Serial No. 13-390A
LIC/JG/R0
Docket No.: 50-305
License No.: DPR-43

DOMINION ENERGY KEWAUNEE, INC.
KEWAUNEE POWER STATION
SUPPLEMENT 1 AND RESPONSE TO REQUEST FOR ADDITIONAL INFORMATION
REGARDING REQUEST FOR EXEMPTIONS FROM PORTIONS OF 10 CFR 50.47
AND 10 CFR 50, APPENDIX E

**RESPONSE TO REQUEST FOR ADDITIONAL INFORMATION:
REQUEST FOR EXEMPTIONS FROM PORTIONS OF 10 CFR 50.47(b),
10 CFR 50.47(c)(2), AND 10 CFR 50, APPENDIX E, SECTION IV**

Figure 7-1: Heat-Up Time vs. Decay Time

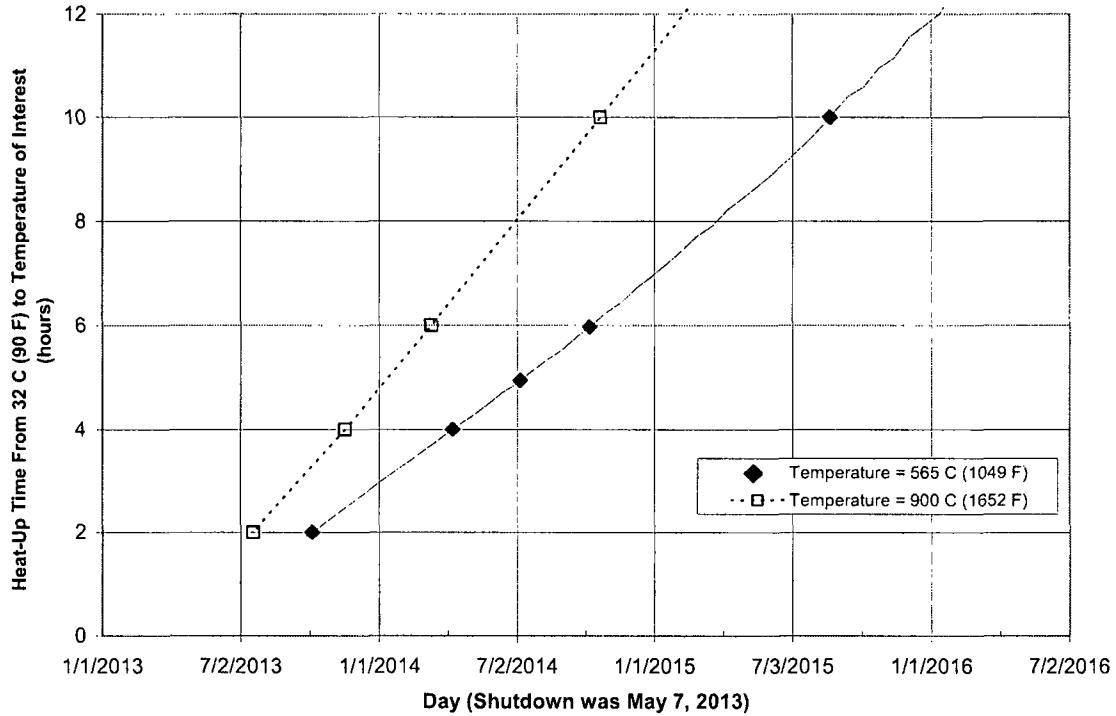
Page 43 of 55 references a site-specific adiabatic heat up to address a partial drain down of the SFP (identified as Reference 12), assuming no air-cooling it states that the time necessary for the hottest fuel assembly to reach the critical temperature of 565°C is six hours after the fuel rods have become uncovered. Some previous exemptions were granted based [on] time to reach the cladding auto-ignition temperature of 900°C. Based on 17 months of decay time, at what time after the fuel is uncovered, assuming an adiabatic heatup, would the hottest fuel assembly reach 900°C? Please provide a copy of this analysis and the existing analysis for the Partial Loss of Cooling Water Inventory with No Air Cooling.

Calculation 2013-07050, "Maximum Cladding Temperature Analysis for an Uncovered Spent Fuel Pool with No Air Cooling," shows that after approximately 17 months of decay time, the hottest fuel assembly in the spent fuel pool would reach 900°C in 10 hours after the fuel is uncovered, assuming no air cooling (adiabatic heatup) (documented in Section 7, "Results" and Figure 7-1, "Heat-Up Time vs. Decay Time"). Seventeen months of decay time will occur on October 21, 2014.
